PWM Transducer Volts Rev3 Temco Builld pcs: 340

Title	<title></td><td></td><td></td><td></td><td></td><td></td><td></td></tr><tr><td>Size
B</td><td>Document Number
<Doc></td><td></td><td></td><td></td><td></td><td>Rev
<Rev</td><td>Çoc</td></tr><tr><td>Date:</td><td>Monday, February 27, 2006</td><td>Sheet</td><td>2</td><td>of</td><td>5</td><td></td><td></td></tr></tbody></table></title>

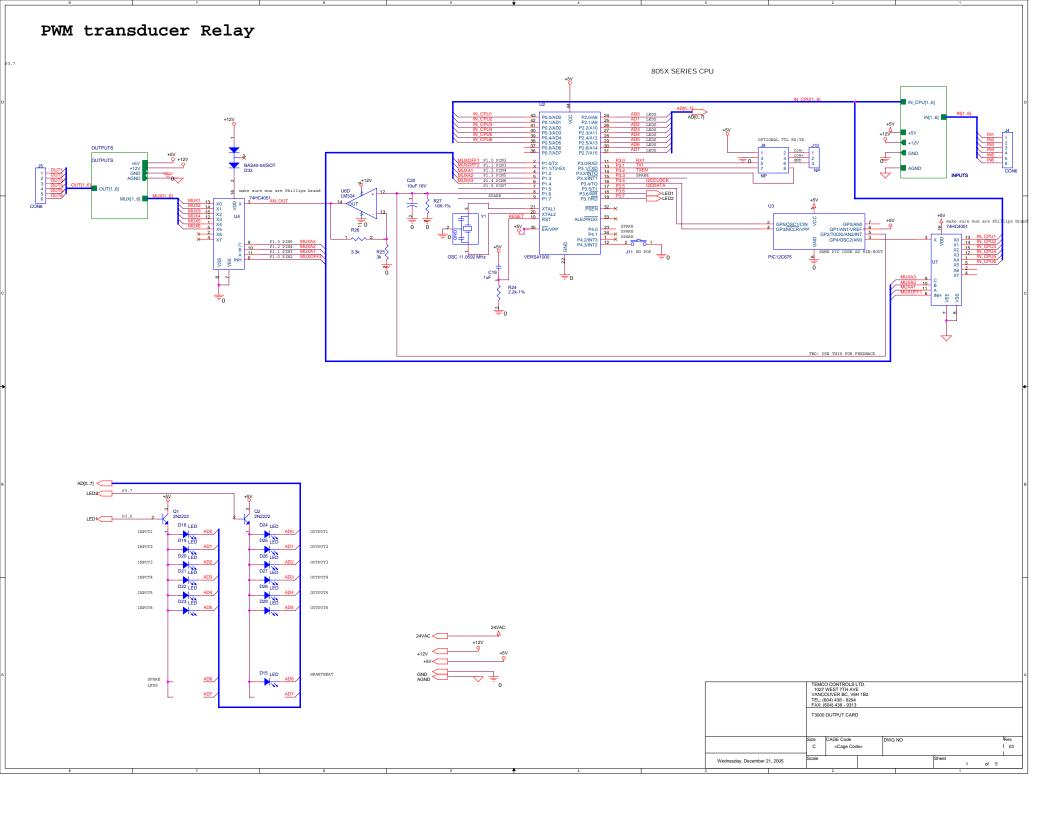
Done: fix mux select lines

Done: require a TXEN line for RS485 com, pin3.2

Done: remove 470 current limitting resistors

Done: flip D33

Done: output feedback to pic should come from 5V side of OPamp

Done: One pin of each "hand" potentiometer must be tied to GND.

Done: Each "hand" potentiometer must be tied to 12V not 5V

Done: Connect analog GND to INPUT page

Done: update footprint of packet resistors

Done: R18 and R22 to move for cpu socket

Done: Outputs out of order on PCB

Done: Make sure all thru-holes have thermal relief

Done: move D33 to make space for pic socket

Done: crystal footprint updated

Done: move IN_CPU2 to Port0 given the internal pull-ups may affect Analog input reads

Done: remove pull up on P0 lines

Done: added diode to decrease 5V line for 485 module, it would overheat otherwise

Done: timing cap for power chip changed to 120pF to reduce noise

Done: changed jumper select to switches

Done: changed the resistance for power to 1.89 and 5.96 for the 5V supply

Done: rectify connection with Input Con. Was mis-labelled

Done: change cap by op-amp to 10uF. 100uF too slow

Done: fix footprint of switches

TBD: rectify footprint names of 2N2222, Q1, Q2 for BOM purposes

Slick Screen on Board was mislabelled. Still reads Rev2

note: make sure muxes are phillips brand. Does not

work with Texas chips
